**WORCESTER TOWNSHIP PLANNING COMMISSION MEETING
REMOTE MEETING
THURSDAY, DECEMBER 10, 2020, 7:30 PM**

Reference: Gunsalus Tract – Revised Subdivision Plans

RE: **Traffic Review #2 – Land Development Plans**
Gunsalus Tract (LD 2020-04)
Worcester Township, Montgomery County, PA
McMahon Project No. 820847.11

RE: **Traffic Review #1 – Residential Subdivision Plans**
2625 Skippack Pike (LD 2020-06)
Worcester Township, Montgomery County, PA
McMahon Project No. 820978.11

WATER SERVICE CONNECTION DETAIL
N.T.S.

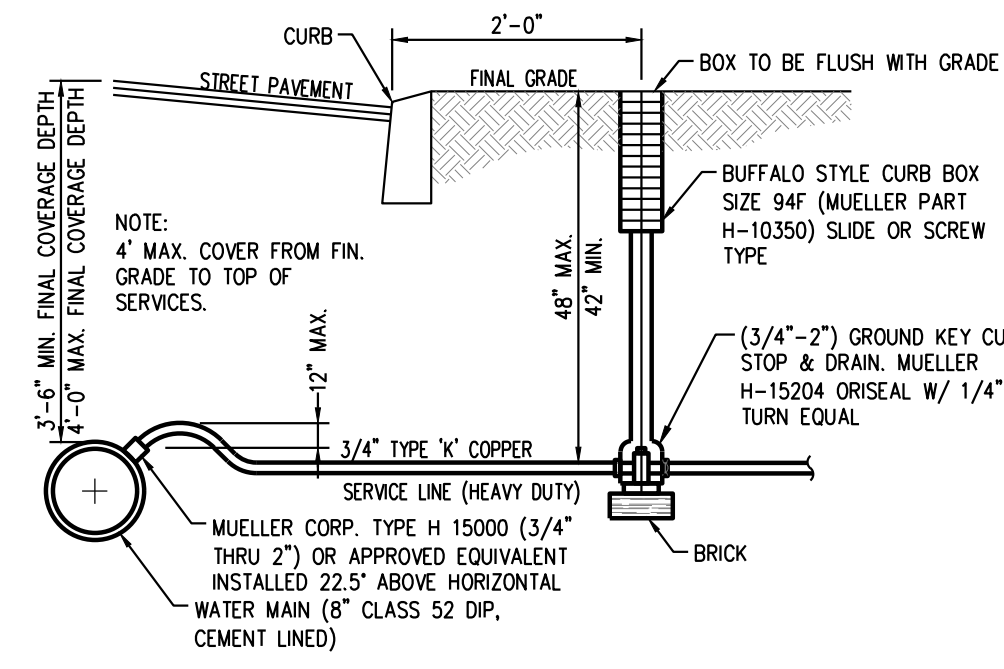
- 5. Sheet No. 5 includes construction details for this project. This sheet includes a "water service connection detail" which should now be removed since public water is not being provided for this project.
